URGENT - FIELD SAFETY NOTICE

To all users of Olympus EVIS EXERA III Gastrointestinal Videoscope **GIF-1TH190 (All serial numbers)**

Re: Revised Instructions of Updated Drying Procedure for the GIF-1TH190.

EVIS EXERA III GASTROINTESTINAL VIDEOSCOPE

Figure 5.90

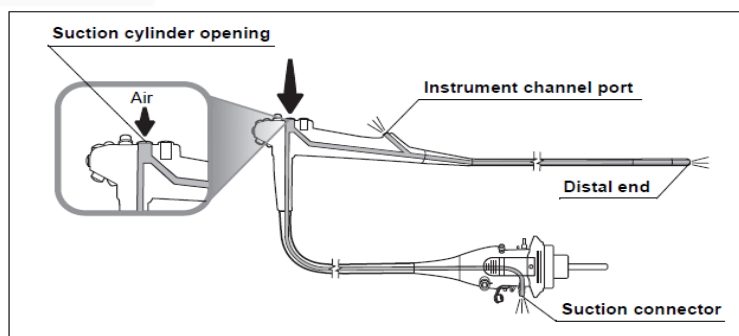
2. Supply compressed filtered air at a pressure of 0.2 – 0.5 MPa into the suction cylinder opening until no alcohol or water exits from the distal end, the instrument channel port, or the suction connector. Supply compressed air for 3 minutes minimum for alcohol and 90 seconds minimum for water.

Figure 5.91

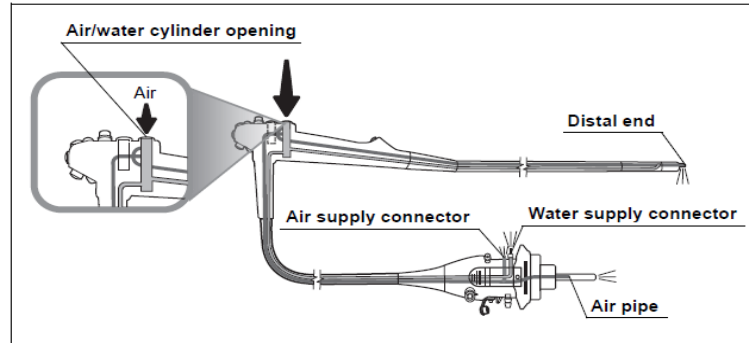
3. Supply compressed filtered air at a pressure of 0.2 – 0.5 MPa into the air/water cylinder opening until no alcohol or water exits from the distal end, the air supply connector, the water supply connector, and the air pipe of the endoscope. Supply compressed air for 3 minutes minimum for alcohol and 90 seconds minimum for water.

Figure 5.92

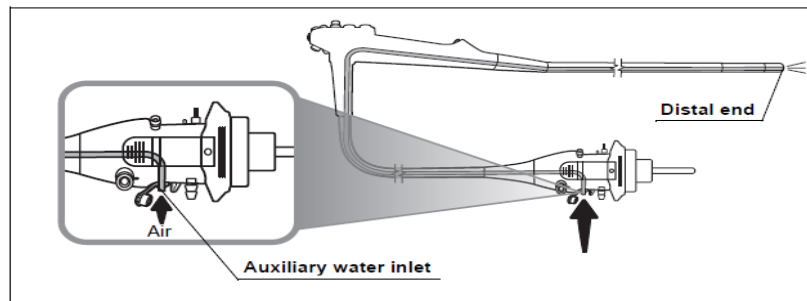
4. Supply compressed filtered air at a pressure of 0.2 – 0.5 MPa into the auxiliary water inlet until no alcohol or water exits from the distal end of the endoscope. Supply compressed air for 3 minutes minimum for alcohol and 90 seconds minimum for water.

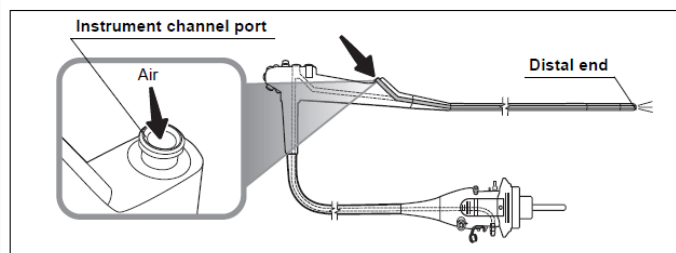
5. Supply compressed filtered air at a pressure of 0.2 – 0.5 MPa into the instrument channel port until no alcohol or water exits from the distal end of the endoscope. Supply compressed air for 3 minutes minimum for alcohol and 90 seconds minimum for water.

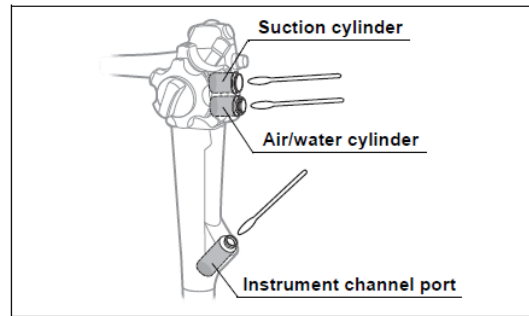
6. Thoroughly dry the inside of the suction cylinder, the air/water cylinder, and the instrument channel port of the endoscope, using sterile cotton swabs.

Figure 5.95

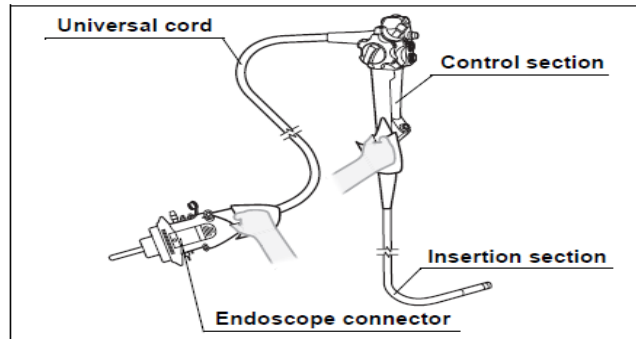
7. Thoroughly dry the external surfaces of the endoscope by wiping with sterile lint-free cloths.
